IEEE P802.15
Wireless Personal Area Networks

Project	IEEE P802.15 Working Group for Wireless Personal Area Networks (WPANs)	
Title	TG3 Proposed d10 PS draft text	
Date Submitted	07 April, 2002	
Source	Jay Bain Time Domain7057 Old Madison Pike Huntsville, AL 35801	Voice: 256 922-9229 Fax: 256 922-0837 E-mail: jay.bain@timedomain.com
Re:	IEEE Draft P802.15.3/D10	
Abstract	This document provides recommended draft text for the Asynchronous Power Save (APS) and Synchronous Power Save (SPS) clauses of the 802.15.3 MAC to be incorporated into D0.10	
Purpose	The recommendations contained in this document are to be applied to the 802.15.3 MAC baseline.	
Notice	This document has been prepared to assist the IEEE P802.15. It is offered as a basis for discussion and is not binding on the contributing individual(s) or organization(s). The material in this document is subject to change in form and content after further study. The contributor(s) reserve(s) the right to add, amend or withdraw material contained herein.

List of changes to go from 02/118r1 to r2 (this document) power save text

Figure 1—Message sequence chart for Wakeup operation

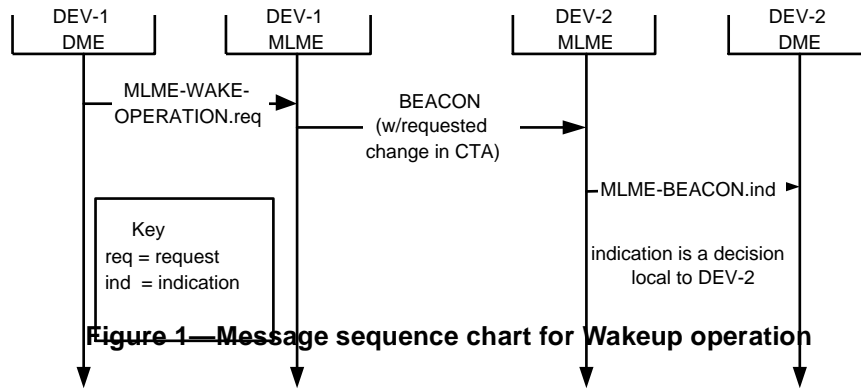
Changed the 15-3MLMEWake-operation-MSC.vsd to reflect agreement of r1 to use beacon indication.

Add PNC to diagram. Show request goes to PNC and PNC generates beacon. Beacon reception causes beacon.indication. There is a table below with a PIB entry related to this. Dump it. 48
49
50

{ps editor note: Since the beacon indicate primitive is the right side of the MSC, make sure that the text and figures match up between this section and the beacon indicate.
